**Flood Control Project Maintenance
Levee Inspections**

Fall 2018 Levee Maintenance Deficiency Summary Report

Reclamation District No. 2107 Mossdale Island

Levee Inspection Report By Mile - Fall 2018

Photo 1 of 1 : FA_2018_RD2107_329_8_20180911_00002.jpg

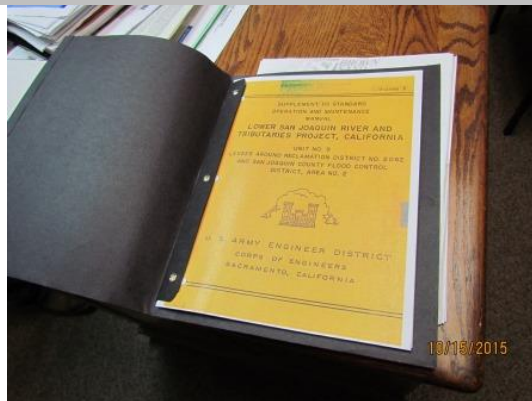
LM Start		Rating **	A	Issue No.	8
LM End		Issue Type +	Ma	Location *	
Category	Earthen Levee		GPS Latitude/Longitude		
			Start	End	
Item	Operations & Maintenance Manuals				
DWR ID	DWR_RD2107_01_s_2013_8				
Comment Code					
Inspector Comment					
The O&M Manual is available at the LMA's office.

Photo 1 of 3 : UCIP_FA_2018_53388_22441.jpg

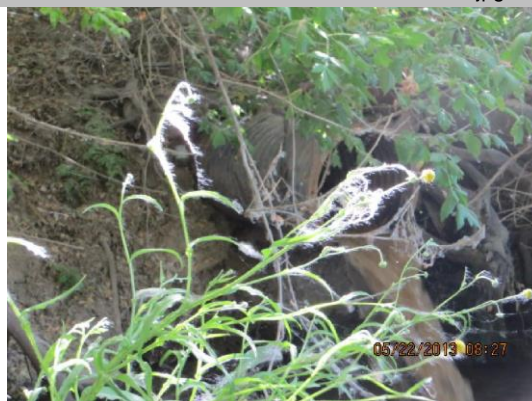
Comment Code					
Inspector Comment					
FS_ID:53388 DS_ID:19056 EP_NO: 2966 Repair Type: Urgent Crossing Status: Found UCIP Comments: 10/10/2018 A temporary flexible pvc pipe installed at this location. Although the levee looks to be in good condition, keeping Urgent due to the temporary nature of this pipe and the need for follow up due to potential levee threat (D. Sanoski - DWR UCIP).11/29/2017 Received update from DWR levee inspector M. Khashchuk and pipe is visible on WS toe with flap gate open: back filled during high winter flow to prevent erosion (no photos are available of back fill work). No updates were provided regarding repairs to the sink hole located on LS toe or internal inspection of pipe through the levee, pipe crossing remains urgent. (DWR UCIP - O. Magana)11/16/2016 Visible hole through pipe visible on WS end. Sink hole present at the LS ditch. Evidence of pipe repair visible on LS (see photos) however, no permit was found to document the work. Need to contact owner to determine permit authorizing work. Due to the hole in the pipe recommend internal inspection of the pipe through the levee to determine pipe integrity. (O. Magana - DWR UCIP)05/22/2013 Headwall around pipe at LS toe is failing and should be shored up. Flap gate propped open and should be returned to normal function. (W. Wylie - DWR UCIP) FIELD_STRUCT_DESC: 24-inch steel drainage pipe through the levee, 14 feet below the crown. Flap gate on the waterside (WS) end of the pipe. Two standard reinforced concrete cutoff walls around the pipe in line with the levee shoulders. (Permit No. 2966, 1958 - Dell'Oso Brothers). FS Date: 10/10/2018 2:37:00 PM

Pipe visible on WS toe with Flap gate open.
